Planning Commission Staff Report

December 12, 2012 Item 6.b.

SUBJECT: P12-0556, P12-0557, and P12-1790

LOCATION: 4191 First Street

FIGURE 3: Site Plan

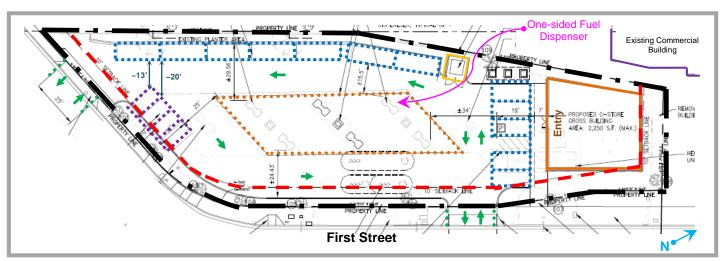
However, staff, including the City Traffic Engineer, has concerns regarding the compact parking space closest to the driveway from Ray Street. This space in its current location blocks incoming traffic since the total aisle dimension is only 13-feet between the parking spaces, and two-way travel requires a minimum of 20-feet. The applicant is willing to move this space to the other end of the parking spaces, which would result in a distance of approximately 20-feet between the end of the western-most compact space and the parallel parking space along the western property line. However, moving this parking space would require a Variance to locate it in the setback area. A Variance would also be required since all four compact spaces have a 2-foot overhang into the front yard setback area along Ray Street, and the eastern-most standard space in front of the convenience market encroaches into the setback area along First Street. As discussed in this staff report, findings for the Variance cannot be made.

Even if this space were to be moved, staff believes the parking spaces adjacent to Ray Street would be underutilized due to the fact that they are on the other side of the site from the convenience market. Additionally, staff believes the parallel parking spaces located along the western property line would underutilized since they are difficult to maneuver into and out of. Thus, many people will likely park in the area along First Street instead of these designated parking stalls. Additionally, vehicles pulling into or leaving the spaces in front of the convenience market will conflict with the vehicular traffic coming in and leaving the driveway off of First Street.

In order to improve the on-site circulation, the applicant is willing to make the fuel dispenser that is furthest northwest one-sided (labeled as "one-sided fuel dispenser" in Figure 3) so that a vehicle parked in the parallel parking space closest to the trash enclosure can maneuver out of the space. Modifying this fuel pump allows the drive-aisle adjacent to this space to be 15-feet-6-inches wide to allow one-way traffic to travel between the areas in front of the convenience market and the driveway leading to Ray Street. However, a customer may still park his/her vehicle at the one-sided fuel pump if all of the spaces directly in front of the convenience market are taken, resulting in this drive aisle being partially or completely blocked. Furthermore, even with markings on the pavement, drivers may not comply with the one-way circulation system, creating the potential for additional circulation conflicts.

The proposed site plan would meet the minimum number of required parking spaces, but results in poor circulation and locating parking spaces within setback areas and far from the use they serve. For these reasons, staff does not support the parking and circulation.

FIGURE 5: Elevations for Convenience Market and Service Station Canopy

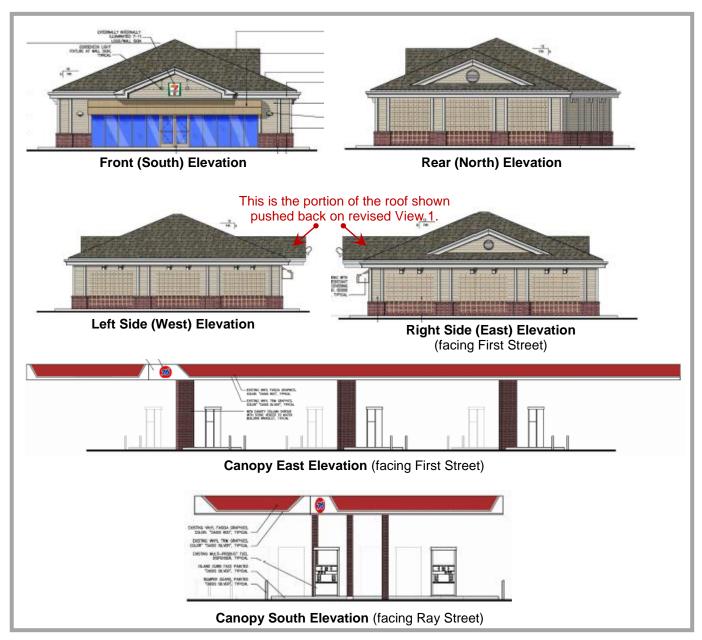
The convenience market's exterior finishes include faux grained Hardieplank[®] lap siding, brick veneer wainscoting, and corbels. Three sides of the building (with the exception of the front) will have wall-mounted metal trellises. The areas along the perimeter of the site would be landscaped. Pervious pavement is proposed for the five parking spaces and walkway in front of the building entrance. The canopy over the service station would remain unchanged, except that brick veneer would be added to the existing columns to match the wainscoting on the convenience market. Please note that the elevations

drawings do not show the canopy's gable ends with a low-pitched standing-seam metal roof, and incorrectly show the "76" logo sign on the First Street side when it is located on the Ray Street side of the canopy.

Although the convenience market will have a landscaped area meeting the above requirements, and an appropriately designed roof, the building lacks windows on the street side, and does not include architectural detail or accents at the pedestrian level, and does not screen parking from view.
